Development Permit Panel Electronic Meeting

1. **DEVELOPMENT PERMIT 18-829108**

PROPERTY LOCATION: 4400, 4420 and 4440 Smith Crescent

The Advisory Design Panel (ADP) has reviewed the project and supports it. A copy of the relevant excerpt from the ADP Minutes from Thursday, June 20, 2024, is attached for reference (Attachment 3). The design response from the applicant has been included immediately following the specific Design Panel comments and is identified in 'bold italics'.

BUILDING 6 -ELEVATIONS

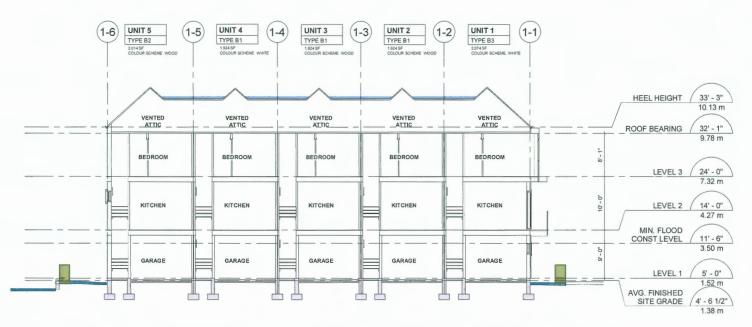
consider further treatment to the west elevation of Building 6 to provide a more visually interesting backdrop to the adjacent common outdoor amenity area;

Building 6 west elevation design was improved; more fronting architectural elements were incorporated (Sheet A103 and A261).
